# Product Change Notification

**Overview:** Please be advised that the following is notice of change to Fire Research pressure sensors.

**Products Affected:** All PT1/PT2 pressure sensors used for intake and discharge pressure displays, portable testers, and pressure governors.

Fire Research Corp.  
 Drawing Number  
 XE-XXPT3DWG.R0A  
 Date 09NOV09

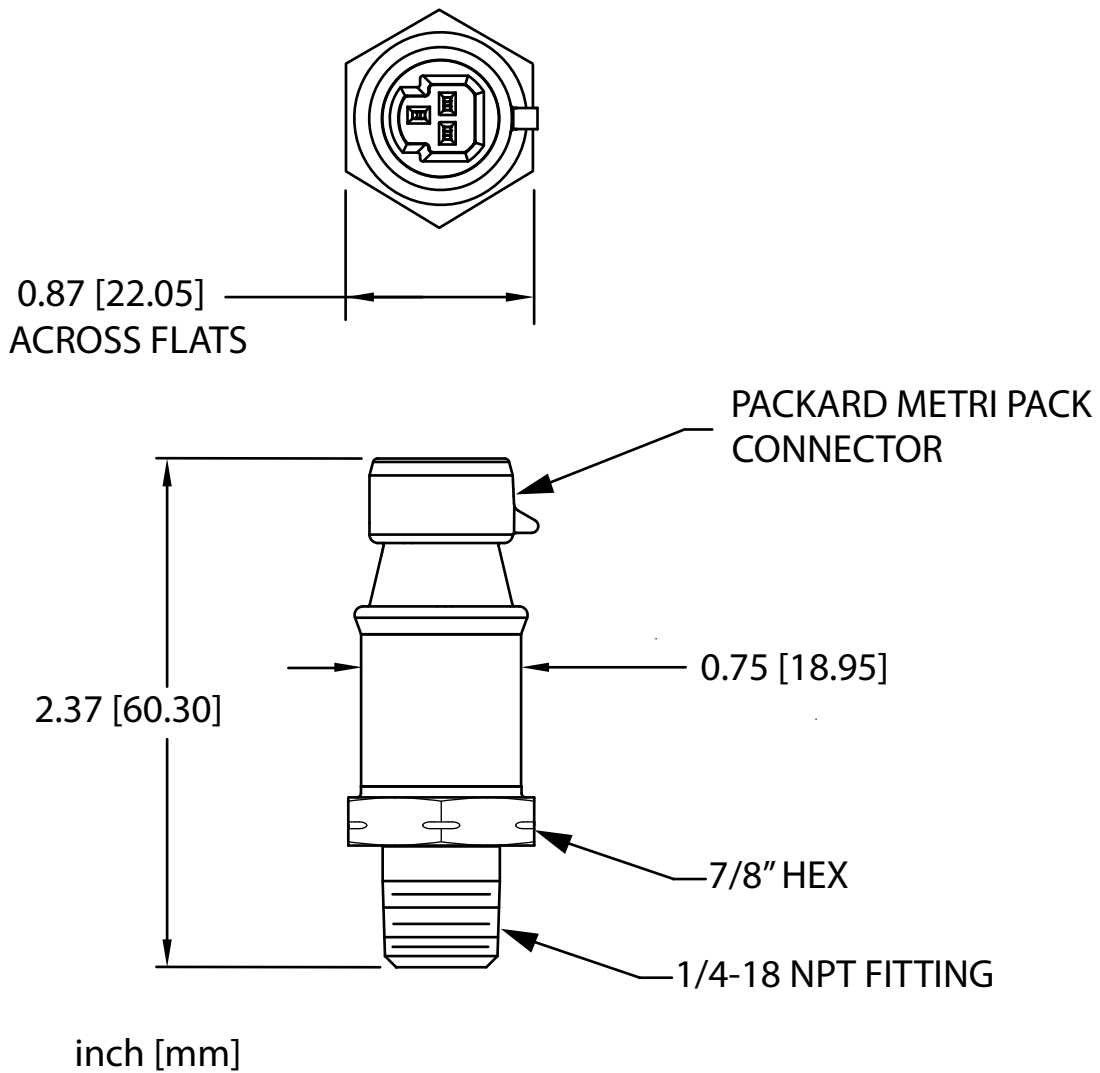
**Change Description:** The above pressure sensors are being discontinued. New PT3 pressure sensors will be direct replacements in all orders starting on or about 07DEC09.

**Replacement Product:** New pressure sensors will be direct replacements. They meet or exceed all electrical and mechanical requirements, use the same 3-Pin Packard connector, and mount in the same size 1/4 inch NPT port.

Important Note: The new sensors are slightly smaller than the old ones in height and width (less 0.6 inch in height and 0.7 inch in width). Refer to the referenced drawing for complete dimensions of the new sensors.

This drawing is valid for pressure sensors with the following FRC part numbers:  
 XE-PRO31PT3-S0A, XE-FP4000PT3-S0A,  
 XE-IO3100PT3-S0A, XE-PRO1000PT3-S0A
